**IFB No. 17-26 Eisenhower Middle School HVAC and Roof Access Renovations**

**RE: ADDENDUM NO. 1**

Changes to Bidding Documents Dated January 13, 2017

PROJECT: EISENHOWER MIDDLE SCHOOL  
HVAC AND ROOF ACCESS RENOVATIONS  
ROCKFORD PUBLIC SCHOOLS 205  
ROCKFORD, ILLINOIS

1 ALT. M1: POOL TUNNEL HVAC PLAN  
SCALE: 1/8" = 1'-0"

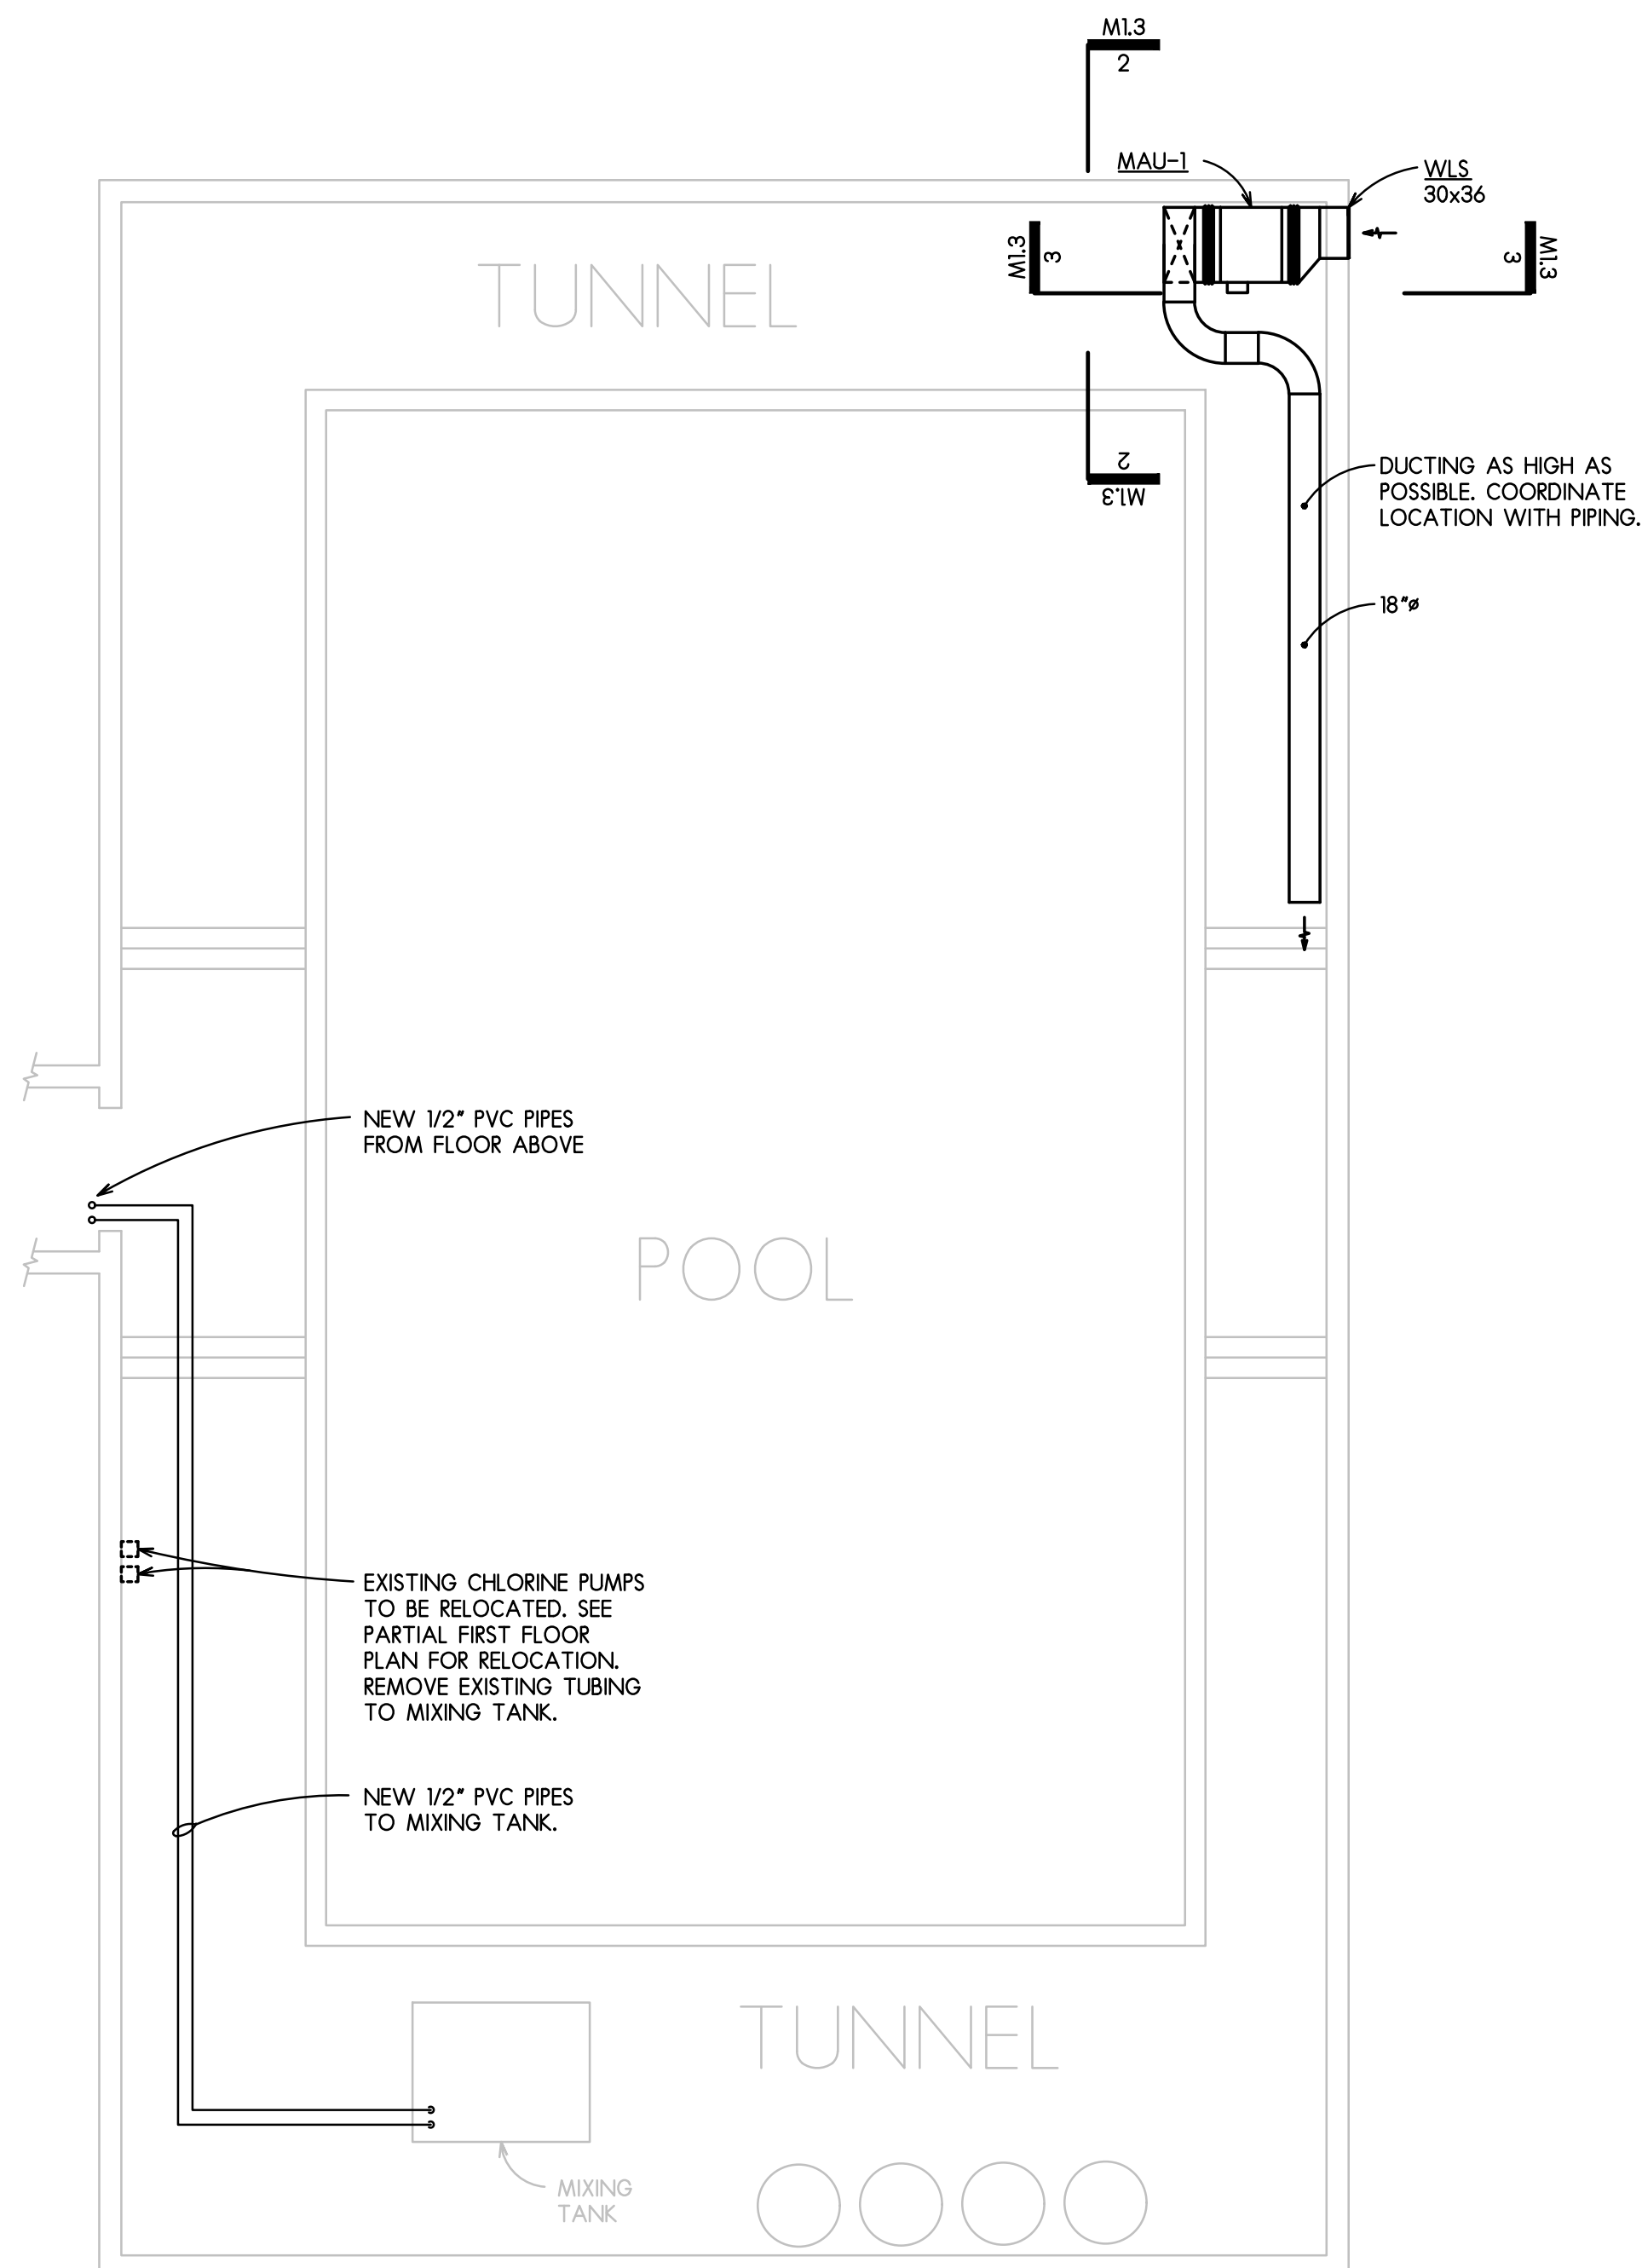
3. Which H.V.A.C. units are part of the pool ventilation, electrical, controls, roof patching, etc.?  
**Refer to attached sheet re-issued sheets M1.3 & E1.0.**
